Addendum No: 9
Date: February 15, 2024
Owner: Northern Health
Stantec # 144320228

This addendum is to be read with and constitutes part of the tender document.

UHNBC (University Hospital of Northern BC) - Pharmacy upgrade

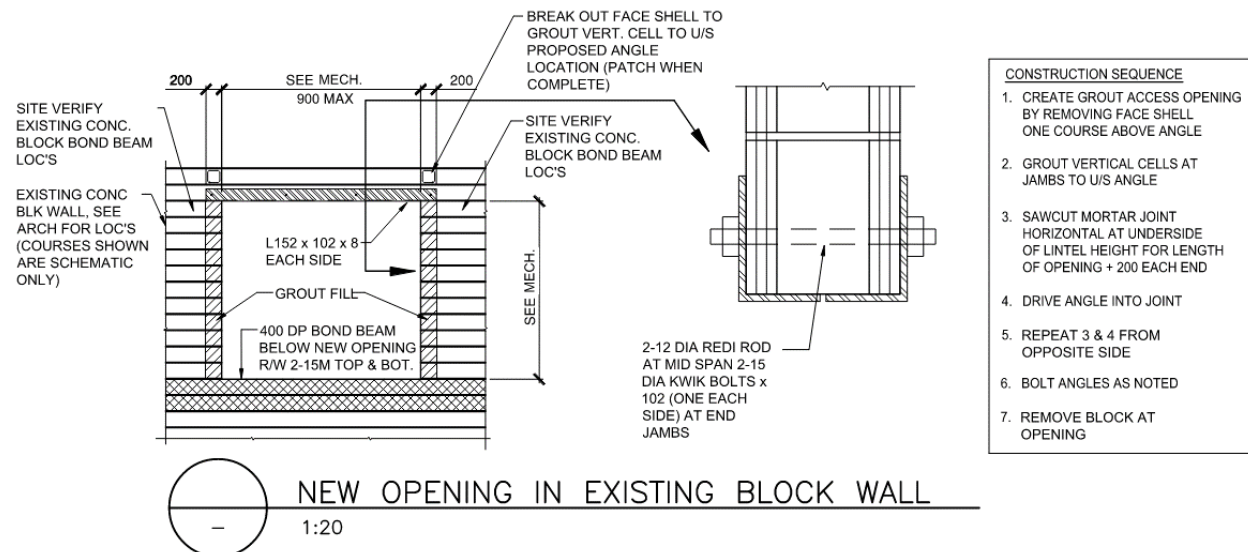
Question: Manufactured Metal Casework

- 1. Due to size and location of “L” shaped worktop on Elev AE201 / 4, worktop will be 2 separate pieces with a mechanical seam. Seam will not be welded. Please confirm.

Answer: Yes, seam not to be welded. No exposed wood in any location, all surfaces need to be 100% cleanable and nonporous as shown on drawings AE302 Millwork details.

Drawing No.
M102

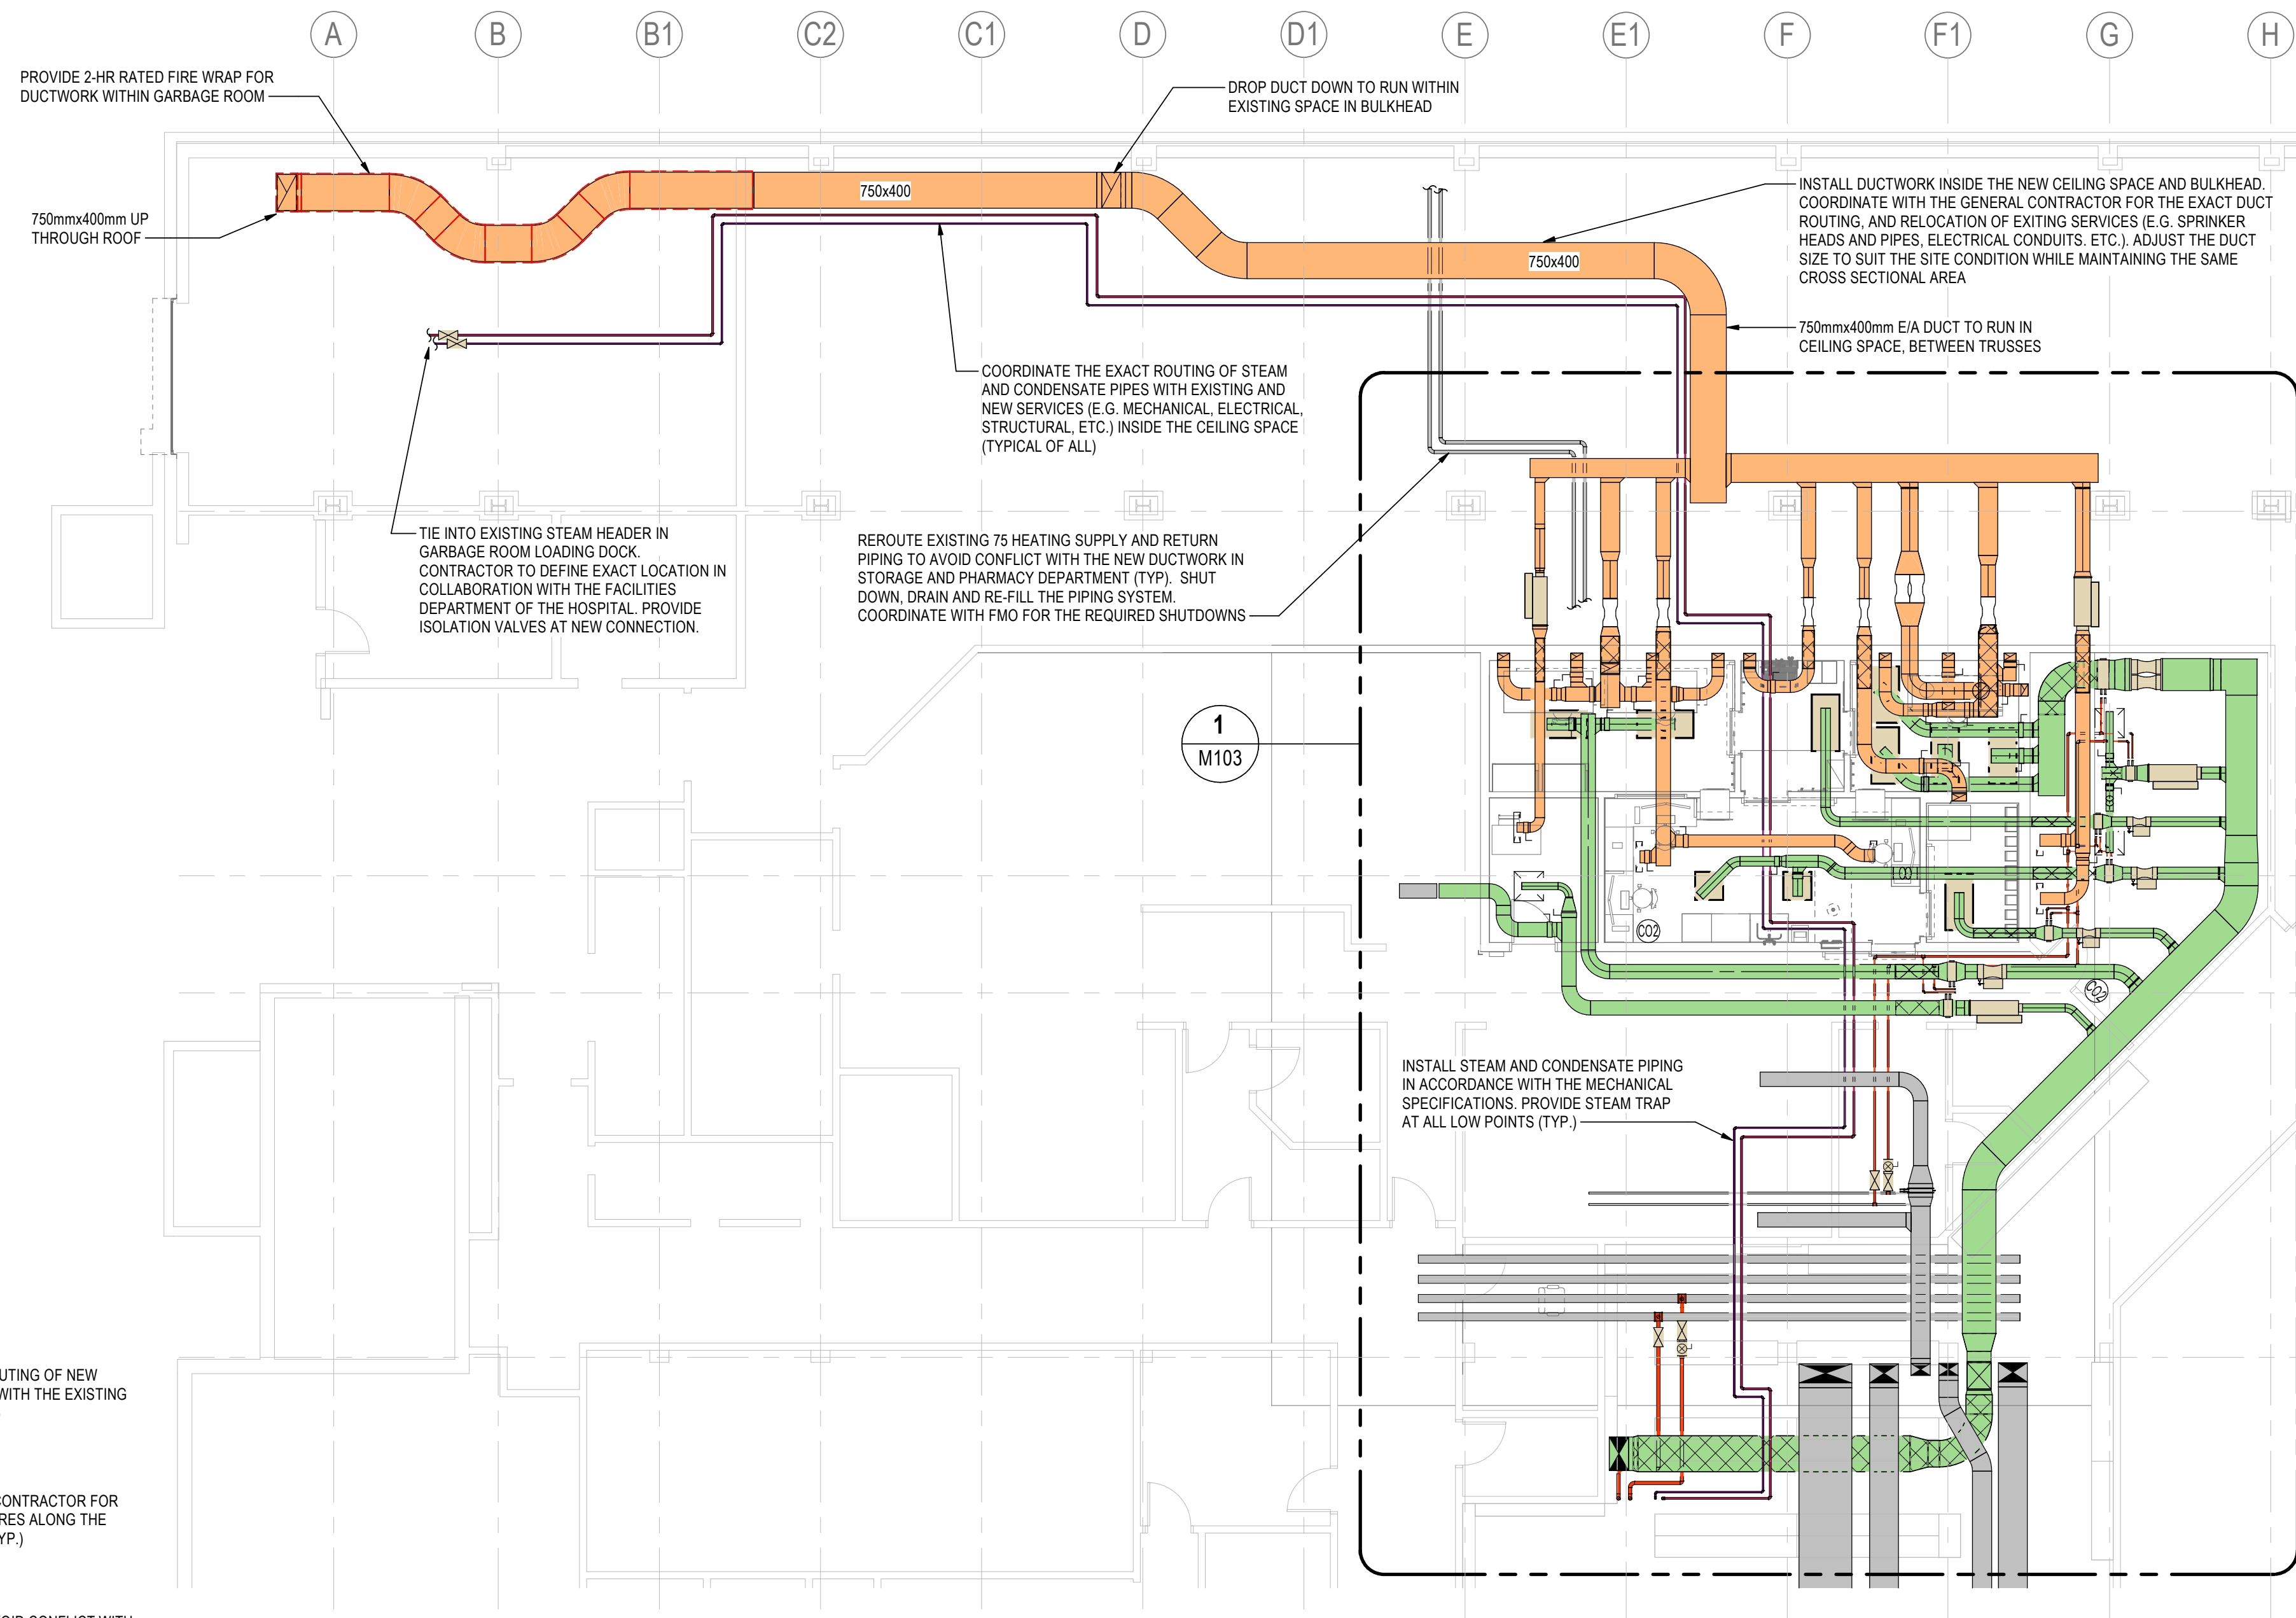
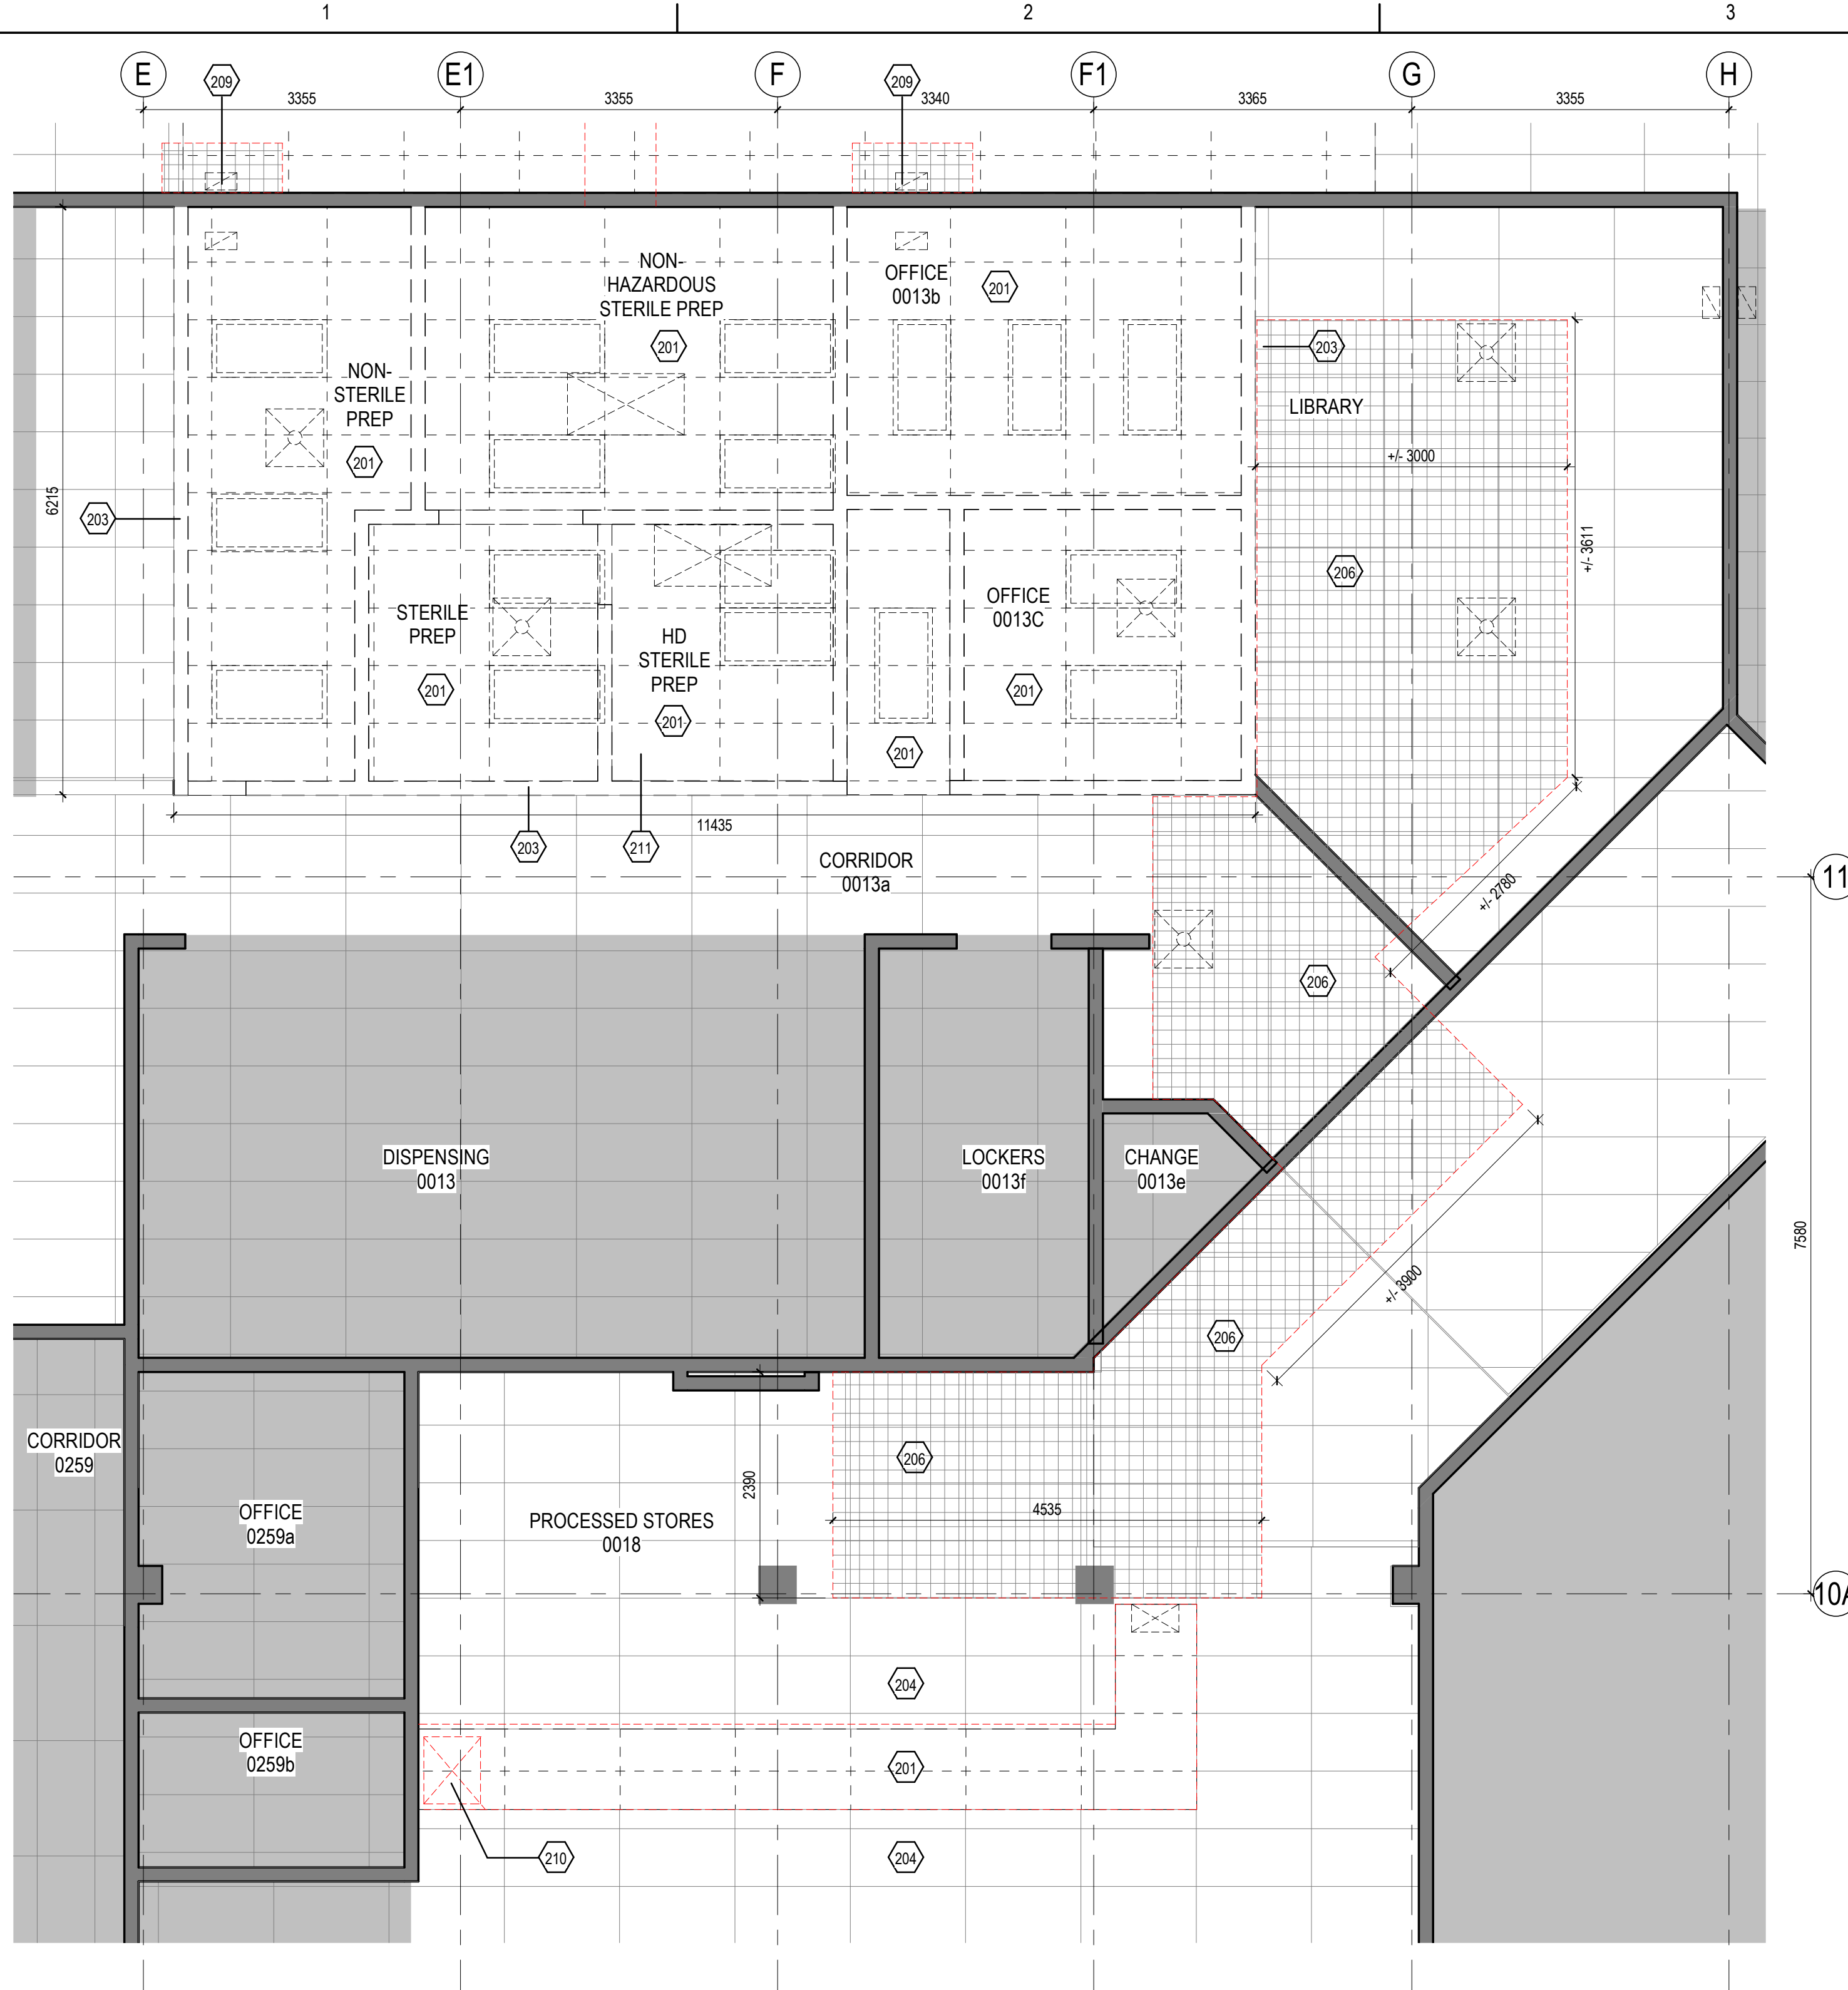
M102 – LEVEL 0 – HVAC – OVERVIEW

Refer to attached sheet M102

Revised EA ductwork routing in Bulk Storage area. Added noting to re & re existing services located in ceiling space.

Revised EA ductwork routing in Garbage Room. Sprinkler piping and heads in Garbage Room to be relocated as necessary.

Added images and notes to provide clarification of EA duct routing and existing services.

Added 2-hr fire wrap for ductwork within garbage room.
